APPLICATION NO.	FILING DATE	FIRST NAMED INVENTOR	ATTORNEY DOCKET NO.	CONFIRMATION NO.
10/548,403	07/27/2006	Marie Bendix Hansen	030307-0266	7935
22428 7590 03/10/2008 FOLEY AND LARDNER LLP			EXAMINER	
SUITE 500 3000 K STREE		KIM, ALEXANDER D		
WASHINGTO			ART UNIT	PAPER NUMBER
			1656	
			MAIL DATE	DELIVERY MODE
			03/10/2008	PAPER

Application No.	Applicant(s)
	10/548,403	HANSEN ET AL.
Office Action Summary	Examiner	Art Unit
	ALEXANDER D. KIM	1656
The MAILING DATE of this communication appeariod for Reply	ppears on the cover sheet with the c	orrespondence address
A SHORTENED STATUTORY PERIOD FOR REP WHICHEVER IS LONGER, FROM THE MAILING - Extensions of time may be available under the provisions of 37 CFR 1 after SIX (6) MONTHS from the mailing date of this communication. - If NO period for reply is specified above, the maximum statutory perio - Failure to reply within the set or extended period for reply will, by statu. Any reply received by the Office later than three months after the mail earned patent term adjustment. See 37 CFR 1.704(b).	DATE OF THIS COMMUNICATION 1.136(a). In no event, however, may a reply be tind d will apply and will expire SIX (6) MONTHS from the cause the

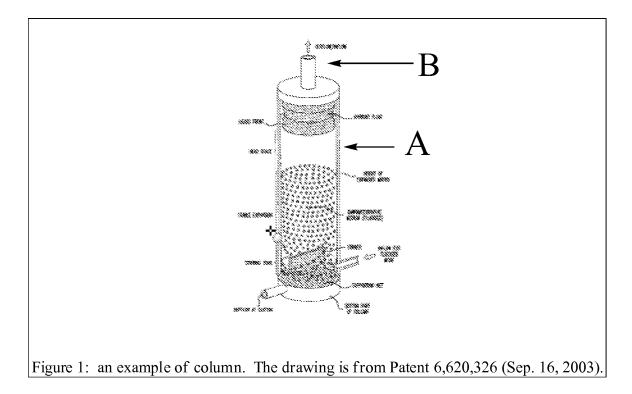
- 6. Claims 1-15 are rejected under of 35 U.S.C. 112, second paragraph, as being indefinite for failing to particularly point out and distinctly claim the subject matter which applicant regards as the invention.
- (a) Claim 1 (Claims 2-15 dependent therefrom) recites the limitation "a linear flow rate of at least 1.500 cm/hour". The recited limitation of a linear flow rate is a relative term which renders the claims indefinite because a linear flow rate represented by cm/hour can be varied depending on a place of measurement in the chromatography system. For example, the linear flow rate at point A is slower than point B in Figure 1, as shown below. Appropriate clarification is required.
